**Review and Evaluation of Characterization Data Provided
for Fansteel Corporation, Muskogee, Oklahoma**

**Thomas Fredrichs
U.S. NRC**

ICF Consulting

November 15, 2002

Figure 8 Surface Contamination Found Through Survey

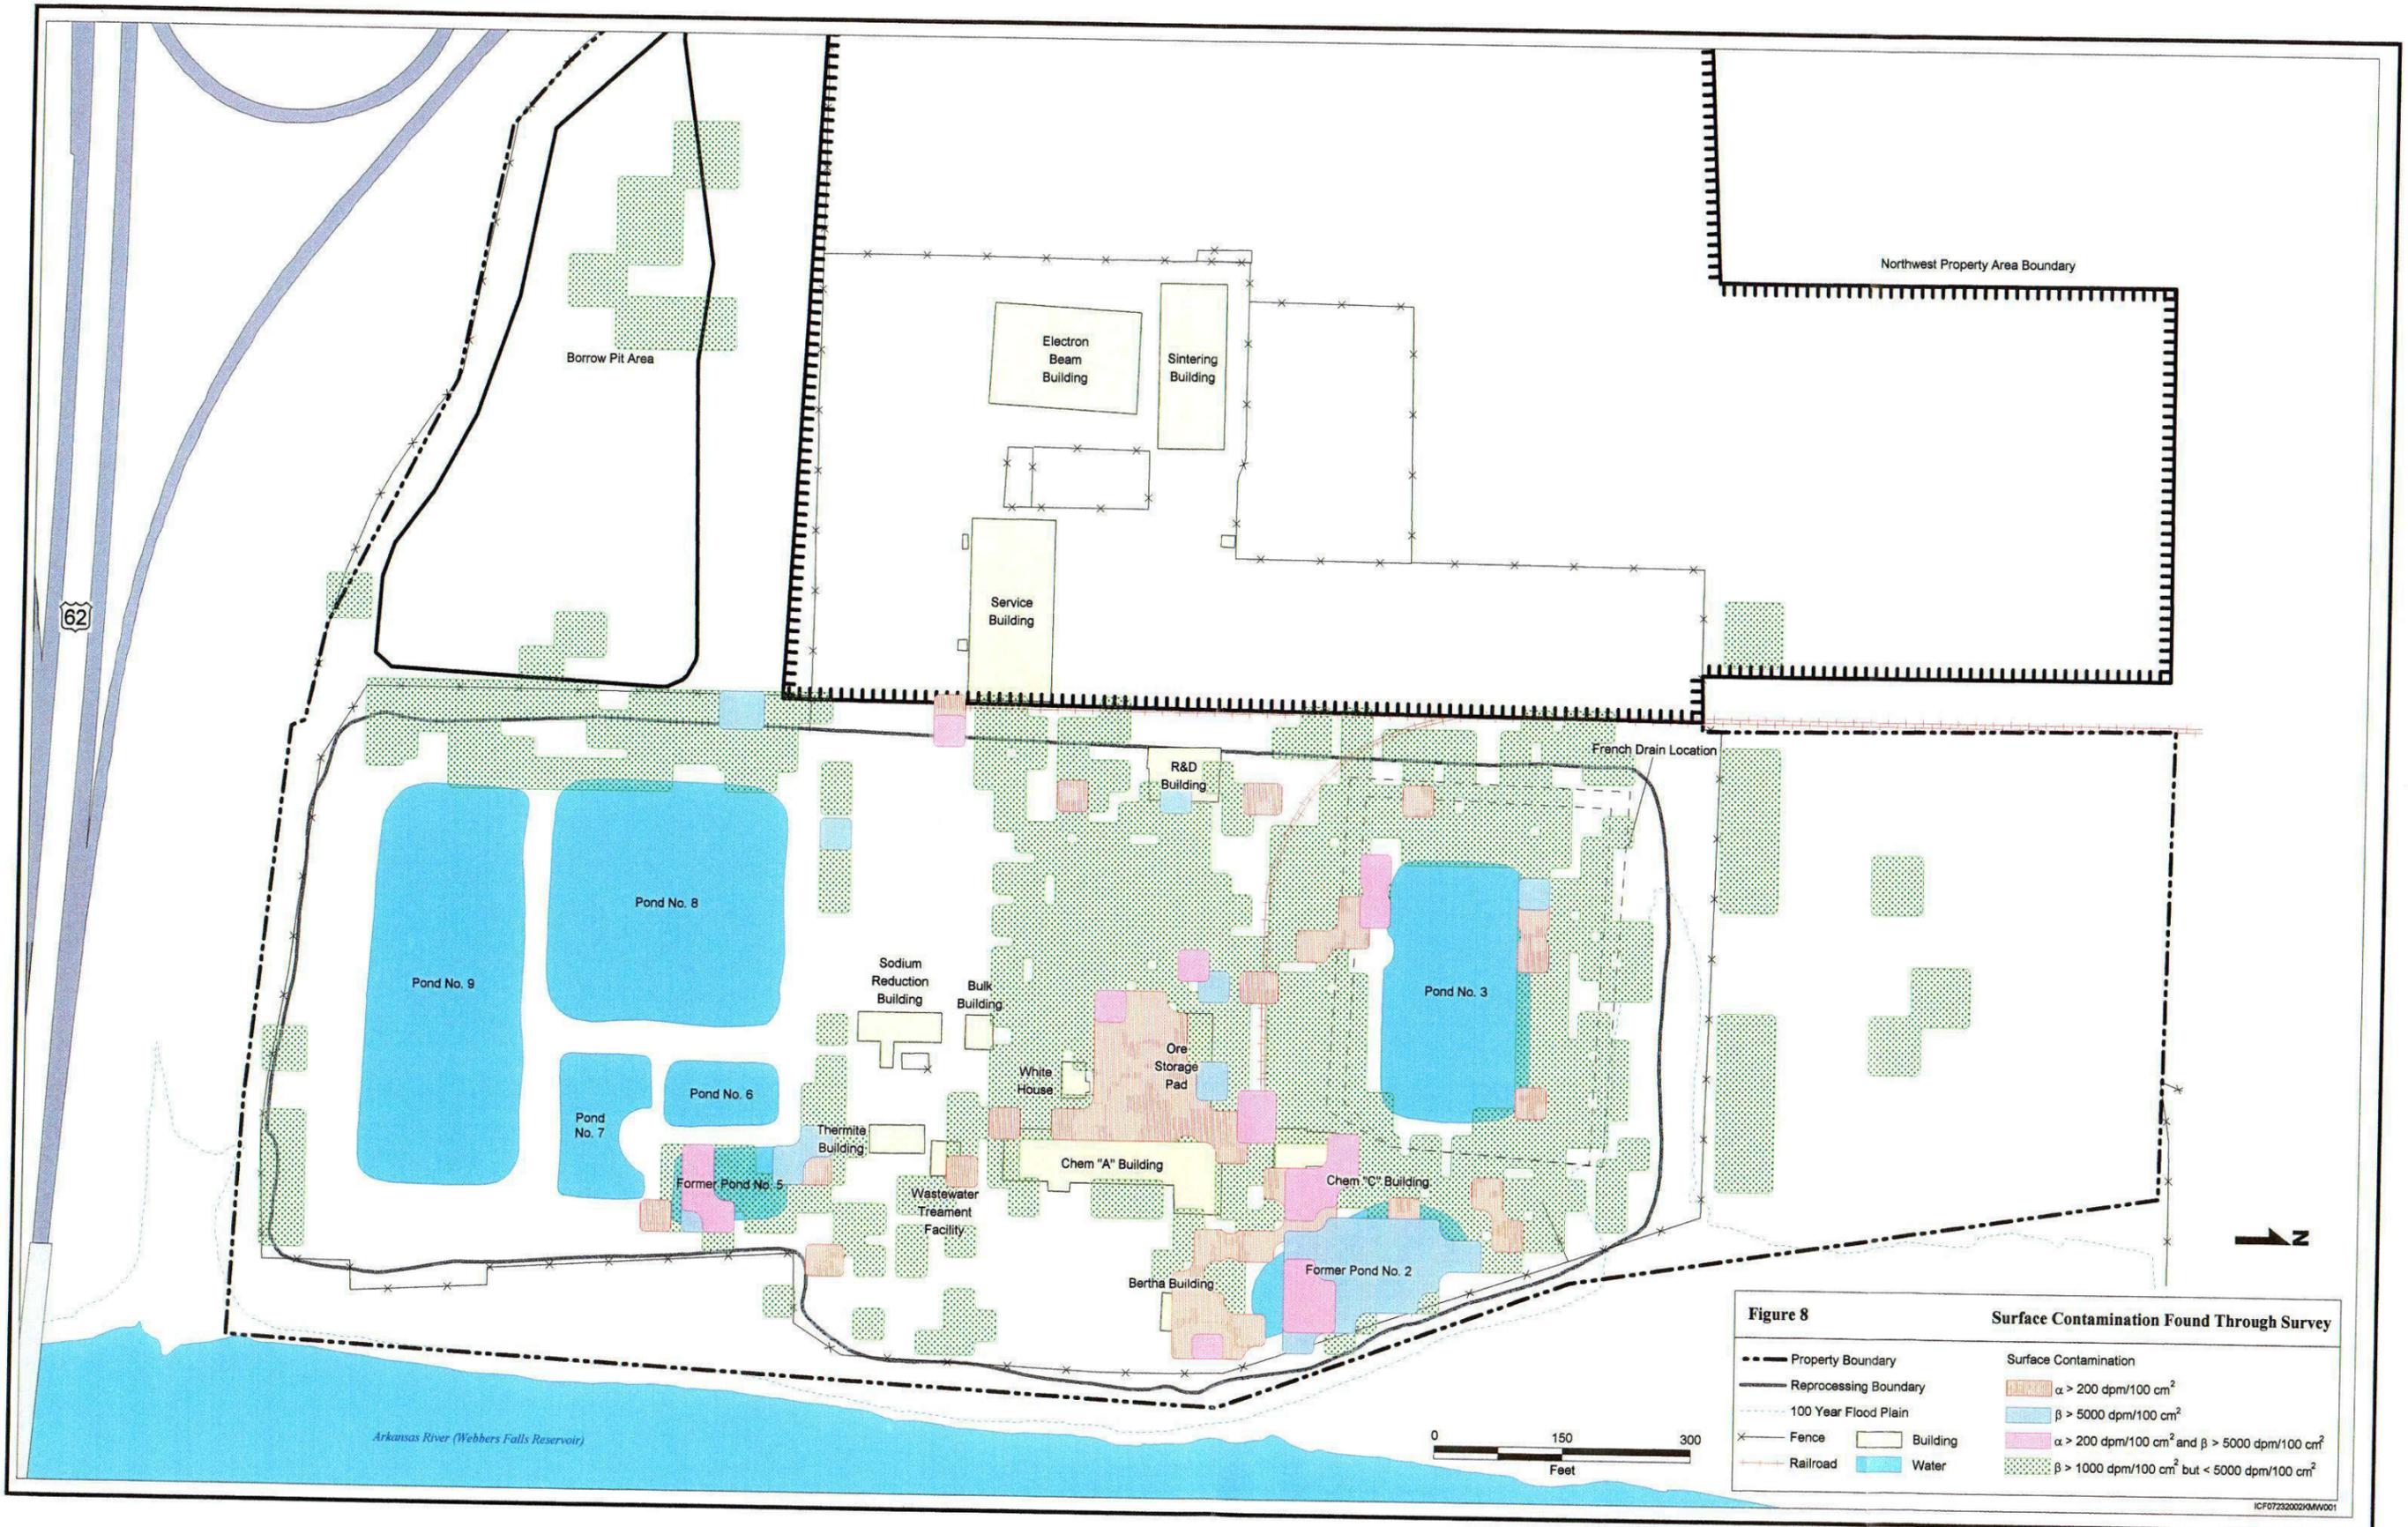
Figure 8 presents the results of the surface scan, by showing where either alpha radioactivity was greater than 200 dpm/100cm² or where beta radioactivity was greater than 1,000 dpm/100cm². While these levels do not automatically trigger cleanup requirements, the presence of radioactivity above these levels does indicate that an area has been impacted. The most obvious concentration of hot spots lies in the east and northeast portion of the property, particularly in the area in and around former Pond 2, west of the Chemical A Building, and all around the Chemical C Building. The area in and around former Pond 5, just south of the Chemical A Building, also has elevated levels of radioactivity. A few other survey points surrounding Pond 3 also have high levels of radioactivity. In addition, much of the rest of the site has beta contamination in excess of 1,000 dpm/100 cm². The source of this contamination is unclear, but may be from windblown contamination.

Figure 9 Soil Contamination Found Through Sampling

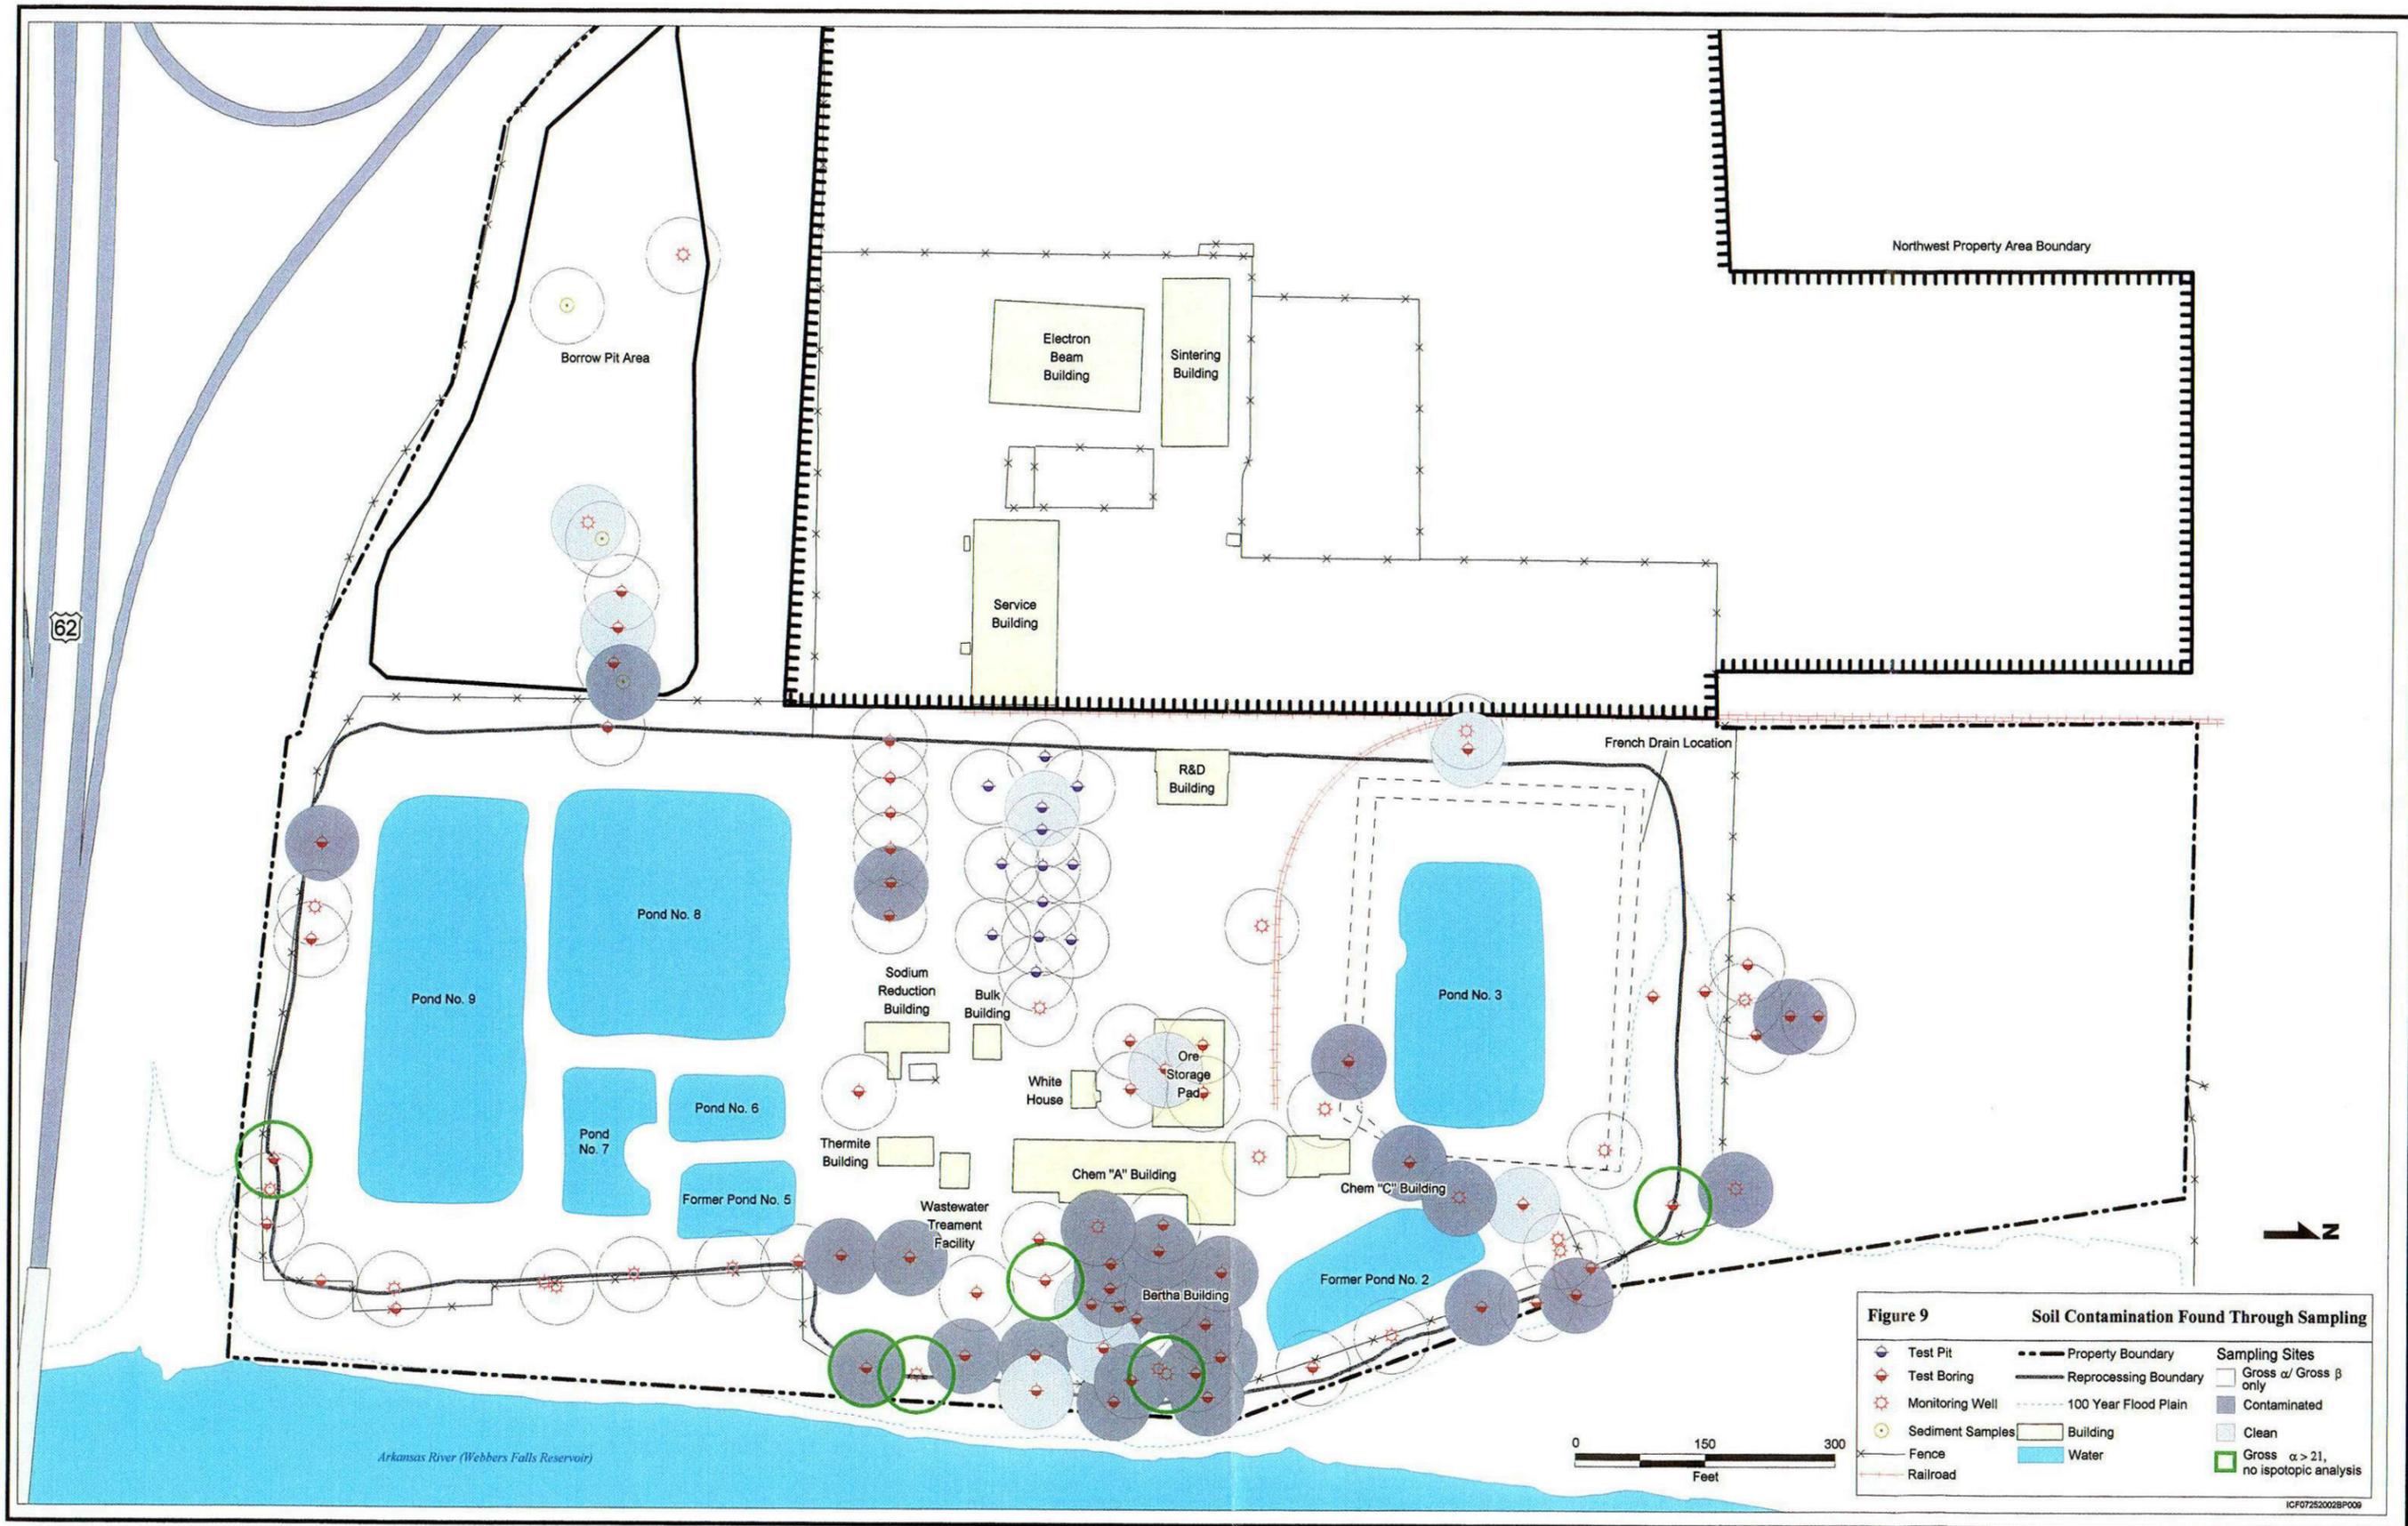
contamination found on the site, and indicates when the combined uranium and thorium levels were above the unrestricted release limit of 10 pCi/g (as stipulated in License Number SMB-911 Amendment 7). Figure 9 presents a map showing locations where the combined uranium and thorium concentrations exceeded the 10 pCi/g unrestricted release level in gray. This figure assumes the area of inference around a sampling point has a 50 foot radius. Sampling locations where only gross alpha and gross beta concentrations were measured are shown as a circle. Samples where the isotopic concentrations were below the 10 pCi/g unrestricted release level are shown in hatching. Finally, samples with gross alpha concentrations equal to or greater than 21 pCi/g but did not have isotopic analysis performed are shown as green circles.

No. The number of samples sent for laboratory analysis appears to be insufficient to characterize the site both with respect to ground area and depth. First, samples sent for
